CITY OF ALBUQUERQUE

RE: **Campbell Compound**
Drainage Report and Grading Plan
Engineer's Stamp Date 10/10/17
Hydrology File: G13D032

OCTOBER 10, 2017

CAMPBELL COMPOUND

SECTION Y-Y
SCALE: 1"=40' HOR.
1"=10' VERT.

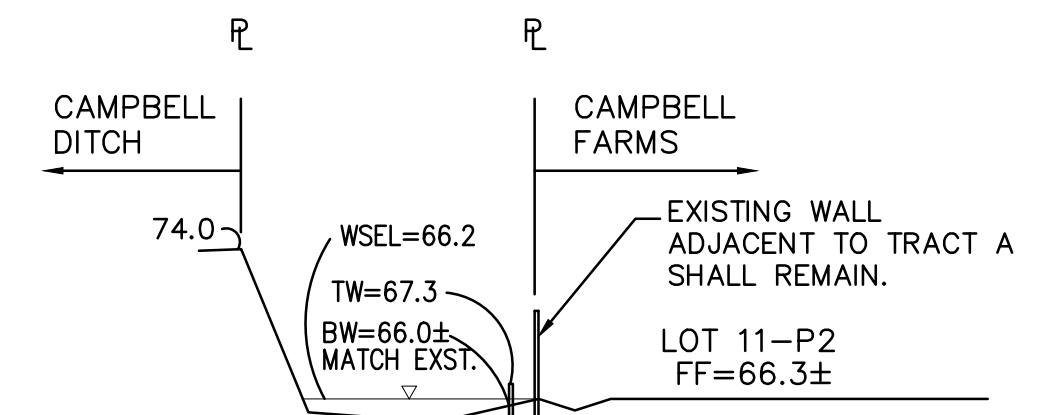
3. Separate Section F-F into two viewports for the different cases. Clearly show that the footer stays off the adjacent property.
4. Modifying an existing privacy wall into a floodwall is not an acceptable course. If a floodwall is desired, a new one will need to be designed and built (Section Y-Y).

2. Section E-E was corrected to show footing on the Campbell Compound side.
3. Section F-F was split into F-F and H-H.
4. The floodwall is shown as a new offset wall with a note that a wall design of the floodwall shall be provided to engineer/City Hydrology prior to approval of grading permit (per discussions with Doug Hughes).

DETAILS & RETAINING WALL PLAN

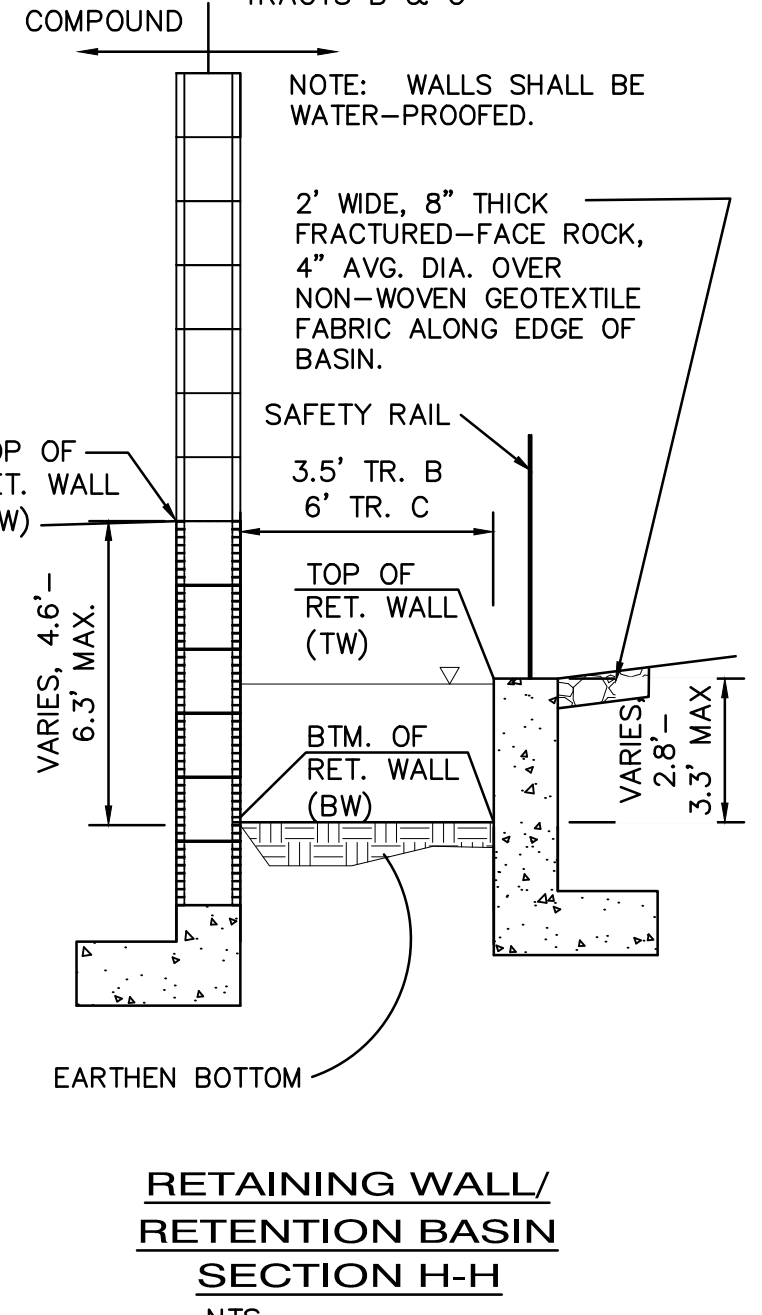
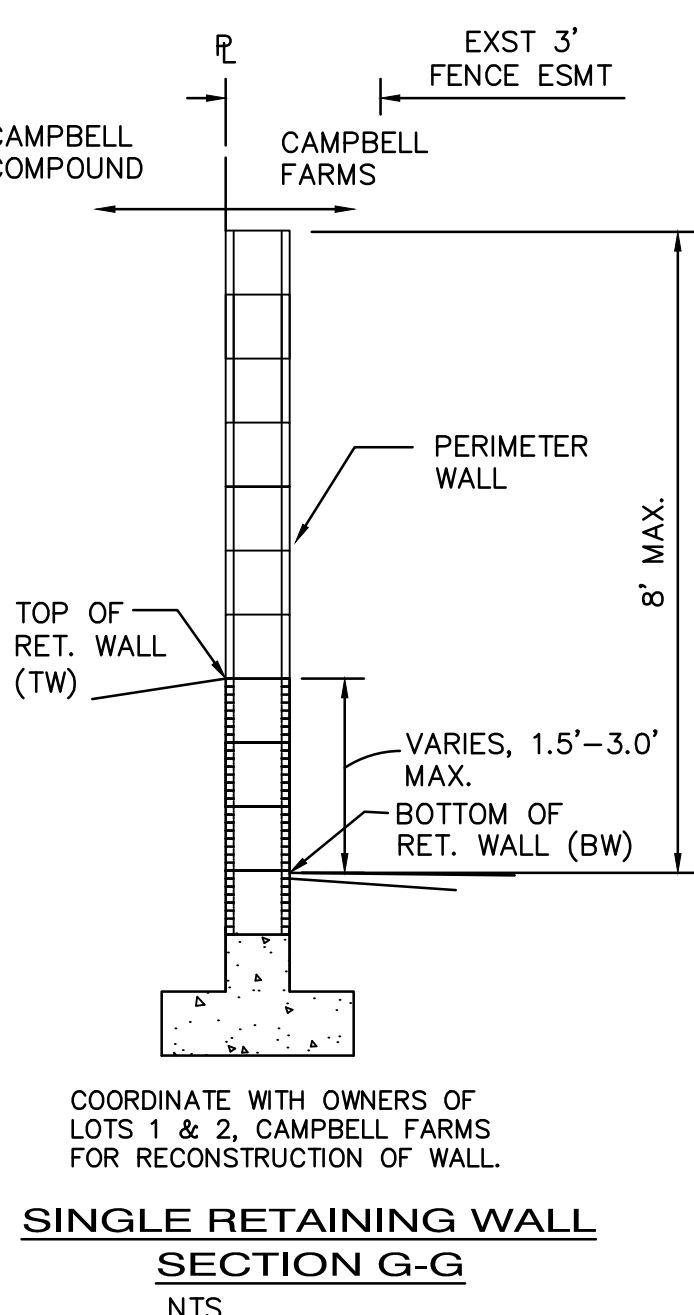
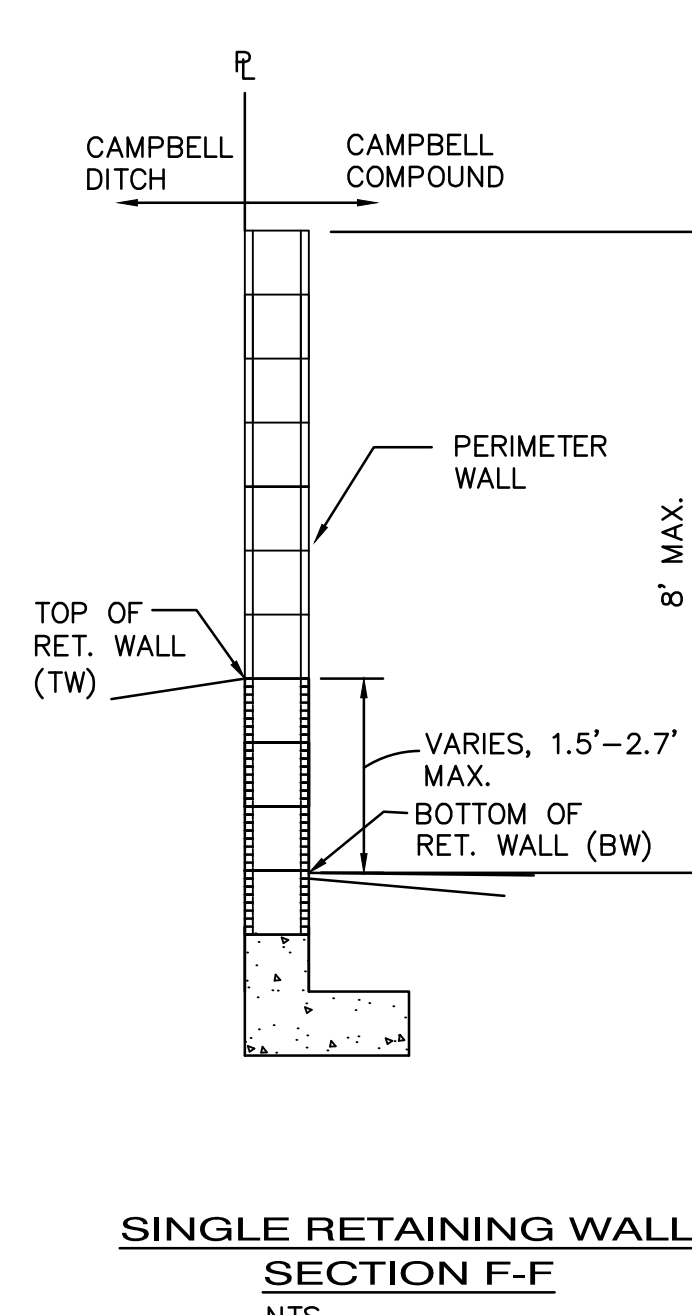
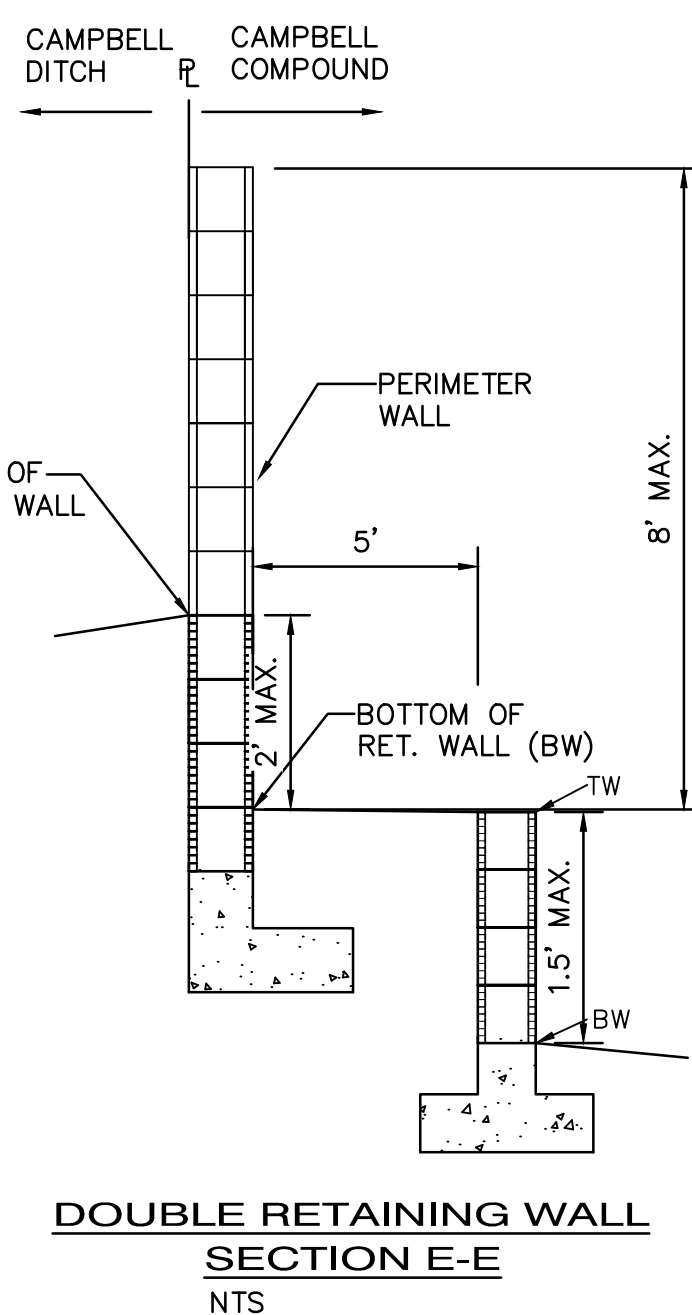
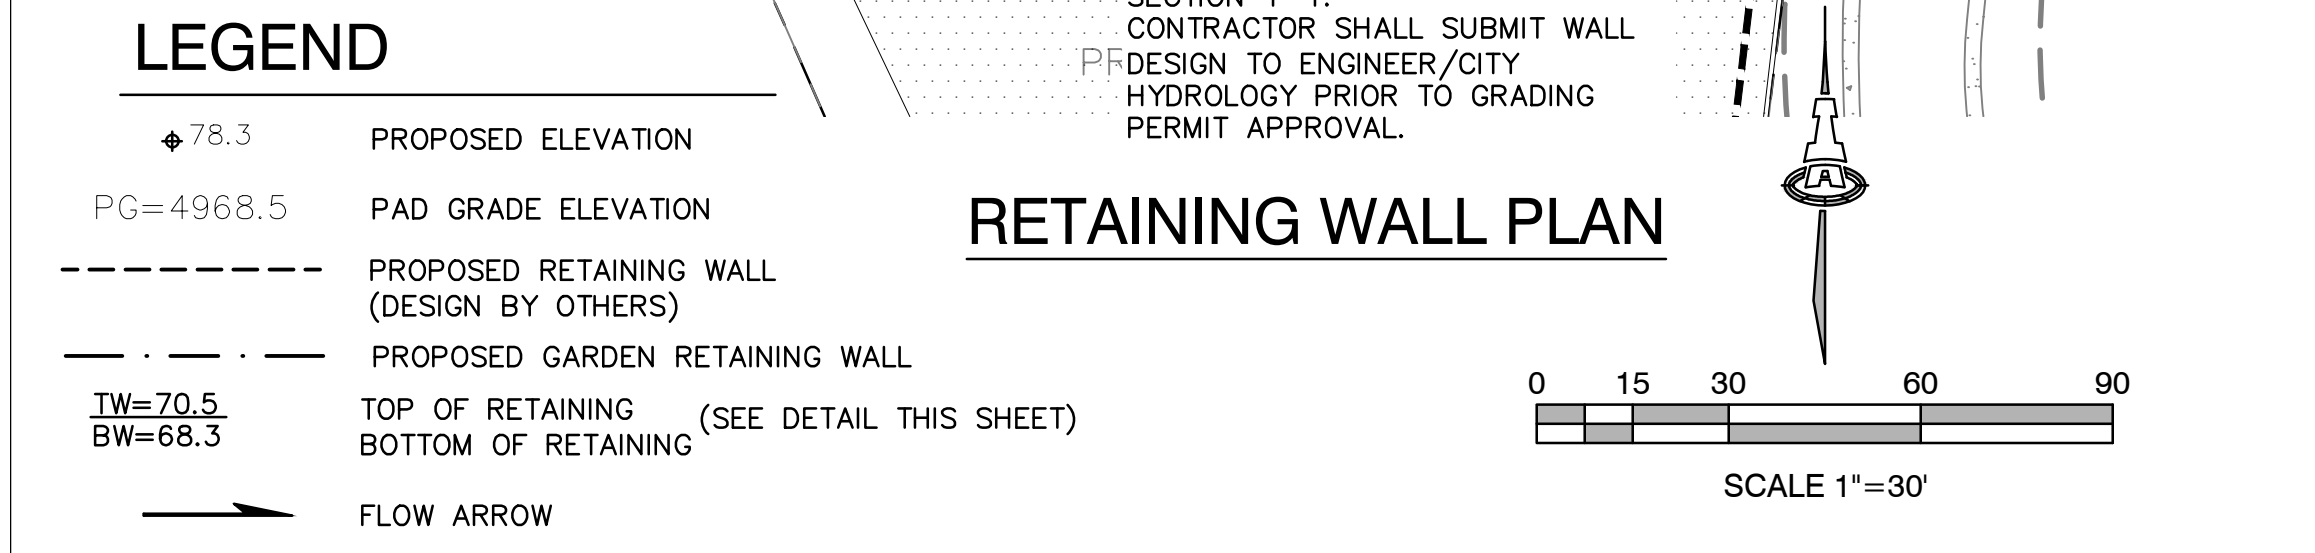
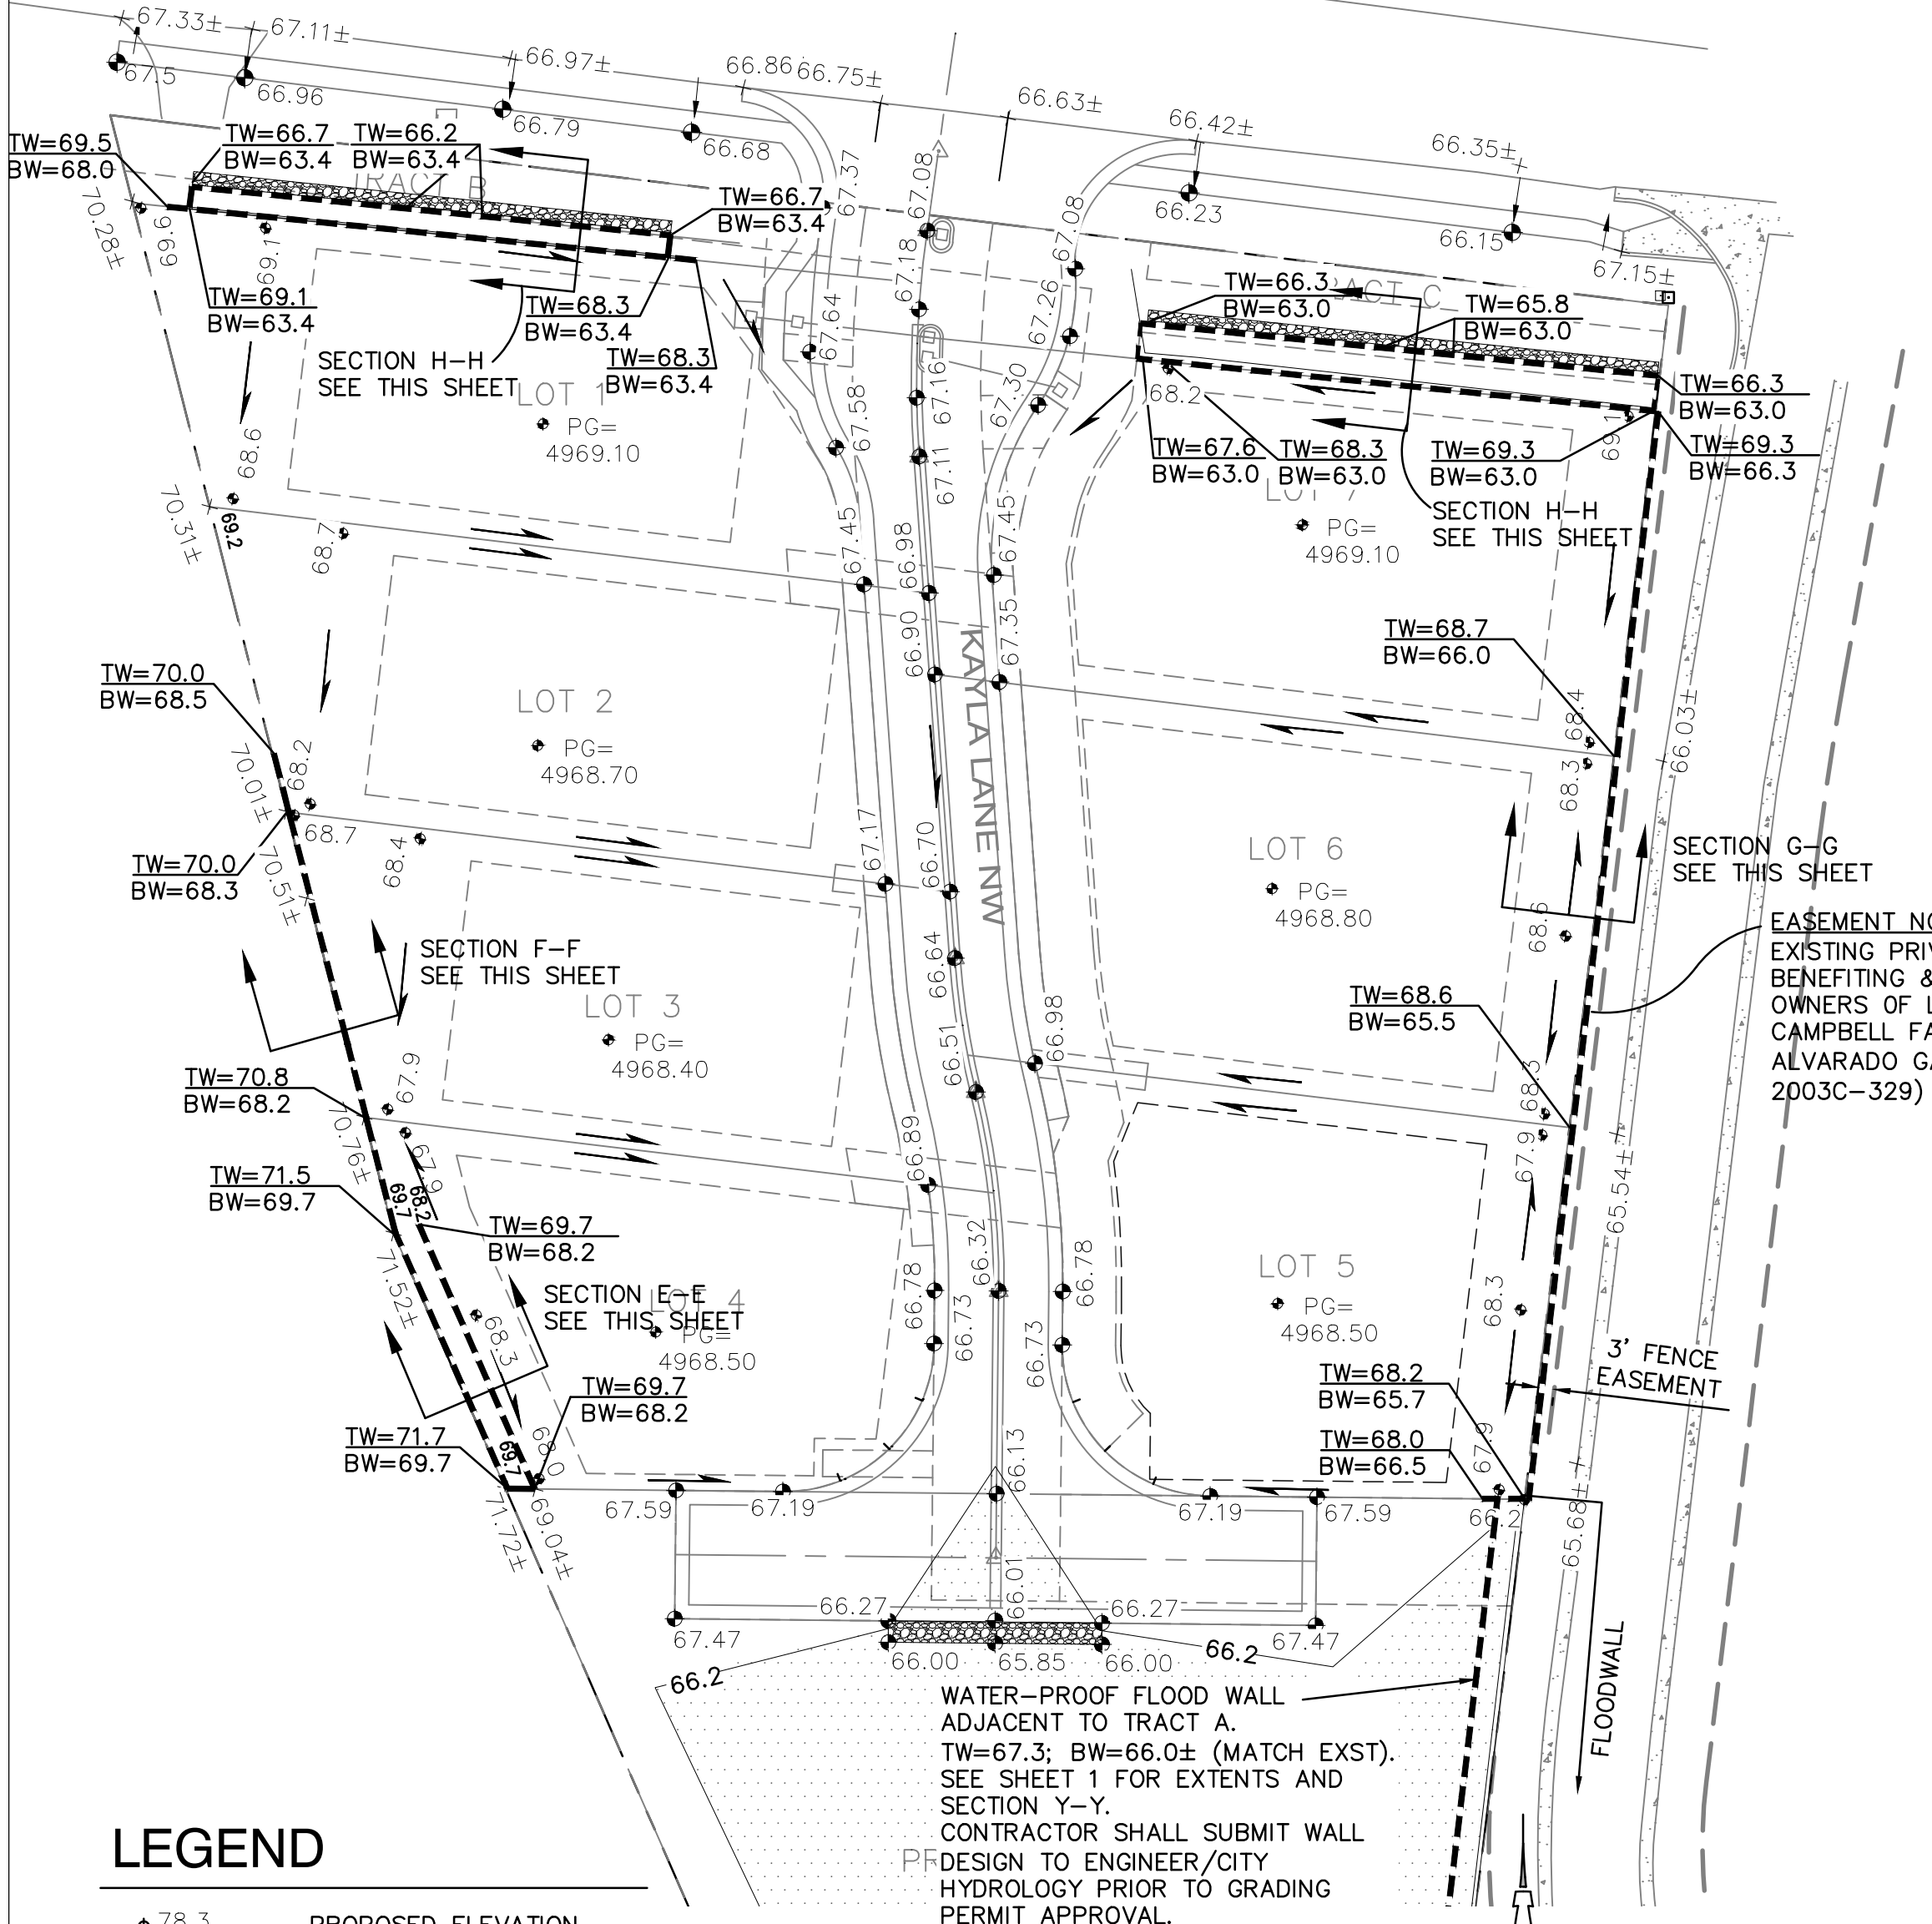
1. Subbasin A needs to include the Campbell Rd half street area and the ponds on tract B & C need to be sized to include this volume.
2. Section E-E on sheet 2/2 shows the retaining wall/privacy wall encroaching across the property line. Correct to show on only Campbell Compound's property.

5. Modifying an existing privacy wall into a retaining wall is not an acceptable course. A new wall will need to be designed and built (Section G-G).
6. Written permission from Campbell Farms HOA will need to be obtained, authorizing any modifications to the common wall. If portions of the wall are owned/maintained by Campbell Farms Lot 11, written permission from that homeowner will be needed as well.

7. the rear-yard retaining wall needs to be 4" (minimum) above the high point of the rear-yard swale invert to promote drainage away from the rear wall and to the front yard (Section B-B and G-G).

1. Campbell half-street was included in the drainage calculations and shown to be ponded in retention basins adjacent to the wall along Tracts B & C. The reason for the retention basins being located along the wall is that the Developer wishes to minimize disturbance within the existing tree area.

5. Section G-G shows a new retaining wall plan in same location as the existing wall—within the 3-foot fence easement located on the Campbell Farms property. See attached for an ALTA survey prepared by Cartesian Surveys that shows this easement. Doug Hughes asked for the original plat that created the easement, which I will forward once I get it from the surveyor.

7. A note that grade at rear-yard wall shall be 4" min. above the rear-yard swale invert was added to Section B-B and reflected on the plan.
